Certified Action of the City of Raleigh Planning Commission

Case File / Name: SP-32-12 / Dillon Supply Warehouse Redevelopment

Nature of Case: The redevelopment/expansion of an existing warehouse building to provide 130,000 square feet of office space and the construction of a parking deck containing 14,000 square feet of retail space and a minimum of 325 parking spaces on a 2.38 acre site zoned Industrial-2 and Downtown Overlay District. The plans also include an optional 224 parking spaces that, if built, would provide a total of 549 parking spaces within the deck. At full build-out of the deck it would be 79.5' in height but allow for possible vertical expansion with a future building. This proposal requires Planning Commission approval because it is for both a change of use and a new building, both of which are over 10,000 square feet in the Downtown Overlay District.

SP-32-12 Dillon Supply Warehouse Redevelopment – Preliminary Site Plan

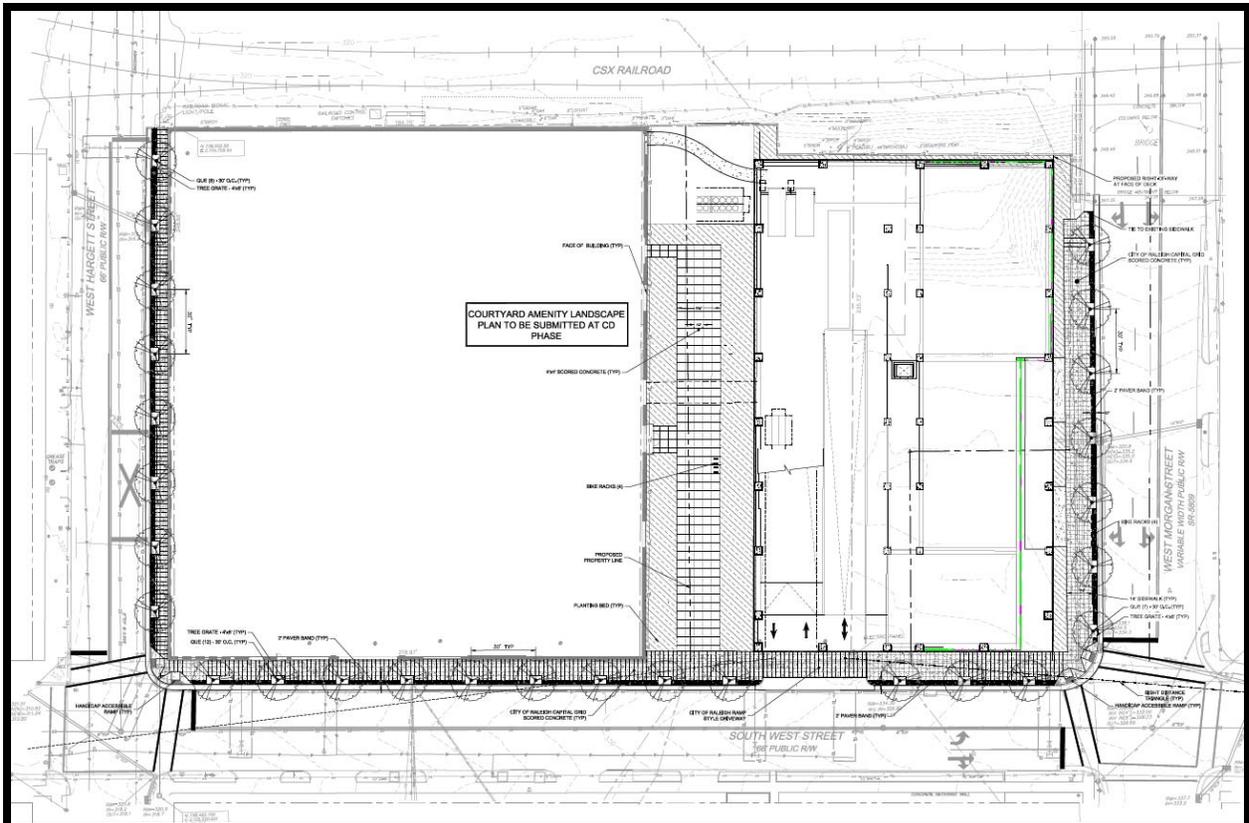
The parking deck needs additional design work to address the following issues:

- Lack of screening at all levels
 - Lack of active ground floor uses.
- Specifically, the Commission discourages the placement of ground floor parking in designated future retail locations, even temporarily. The Commission recommends use of storefront assembly, including glazing for all portions of the ground floor of the parking deck adjacent to the right of way, understanding that, until tenanted, there will not be a finished retail shell behind the storefront assembly. [Commensurate with Code Sec. 10-2132.2(d)(2)].

The Commission applauds the adaptive reuse of the Dillon Warehouse. To further integrate the building into the emerging pedestrian-oriented warehouse district, we suggest the following:

- Incorporate additional significant architectural features such as doors, continuous canopies and /or other strong design techniques to further articulate the façade, announce entryways, and
- Enhance the pedestrian experience along both Hargett and West Streets.
- The Commission supports any requests for encroachments that are necessary to fulfill this objective. [Commensurate with Code Sec. 10-2132.2(d)(2)].

If public entrances cannot be added adjacent to the right of way, the entry sequence in the courtyard needs to be enhanced through signage and architectural features that give an indication of where the public entrance to the building is located. [Commensurate with Code Sec. 10-2132.2(d)(2)].

The Commission supports the design of the courtyard in a way that is akin to a public pocket park. Plantings, fountains or other features are encouraged to terminate the vista at the west end of the courtyard and screen utilities, loading and parking areas. [Commensurate with Code Sec. 10-2132.2(d)(2)].

The Commission suggests the use of root paths, structural soils or other measures to ensure that the required street trees can thrive in the constrained urban planting environment. [Commensurate with Code Sec. 10-2132.2(d)(2)].

The design team concurs with the Commission's suggestion to add canopies and is seeking to do so in a manner that will enhance the aesthetics of the building as well as provide additional natural lighting benefits for the tenant. To that end, we have hired a Day Lighting consultant to advise on the addition of light shelves and canopies over the windows. In keeping with the character of the warehouse district, the supports for the canopies will be made from re-claimed steel located within the existing warehouse structure. To further enhance the pedestrian experience, the design team has also introduced a Vertical Photo Voltaic Panel array that will be hung off of the tower at the corner of Hargett and West Streets. In addition to being a visible source of renewable power generation for the warehouse, this feature will become a landmark for the district, signifying the importance of the Hargett & West Street intersection. We appreciate the Commission's endorsement of encroachment requests to make these improvements to the facades.

Due to the natural terrain slope across the site, additional public entrances cannot be added from the right of way. However, the design team envisions a circular entrance pad to the court yard that would sit partially on the right of way. The pavers used within the court yard will be extended into the sidewalk and an over-head trellis / brise-soleil structure will be created on top of this circular pad. The over-head structure will be manufactured using reclaimed steel from the warehouse. The change in pavement along with the over-head structure will be a strong visual cue to visitors that the entrance of the building is located through the courtyard.

Detailed designs for the courtyard are in early development and will be completed during the construction document phase. The design intent is to use architectural screens and landscape elements to screen mechanical yard and provide a sight line terminus from the street to the west end of the amenity space.
